# UNITED STATES PATENT AND TRADEMARK OFFICE

APPLICATION NO.	FILING DATE	FIRST NAMED INVENTOR	ATTORNEY DOCKET NO.	CONFIRMATION NO.
10/762,782	01/23/2004	Stephen John Lawson		6130

<b>Office Action Summary</b>	<b>Application No.</b> 10/762,782	<b>Applicant(s)</b> LAWSON ET AL.	
	<b>Examiner</b> Lindsay M. Maguire	<b>Art Unit</b> 3634

*Fig. 1*

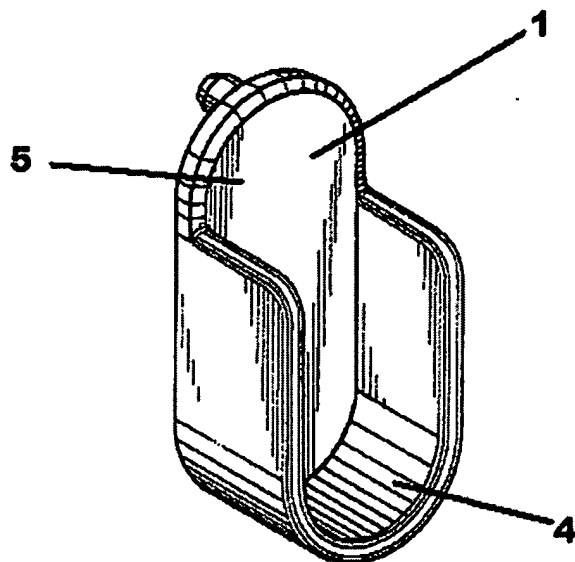
Rogers '573 shows a bracket incorporating a flat base (1; see marked-up copy of Figures 1 and 3 below) having rear (6) and front (5) faces and two pins (2 and 3) projecting from said rear face (6); and a socket (4; it is noted that the definition of a socket, according to Webster's II Dictionary Third Edition, is "an opening into which something fits) on said front face (5) of said flat base (1).

It is noted that since the "inclined support-display assembly" (and all its components) are being functionally recited in lines 1-10 of claim 3, a reference need only be capable of being used with such structure in order to meet the claim language. Thus, although Rogers '573 does not show such structure, it is capable of being used in such a way, and thus is considered to meet the claim language.
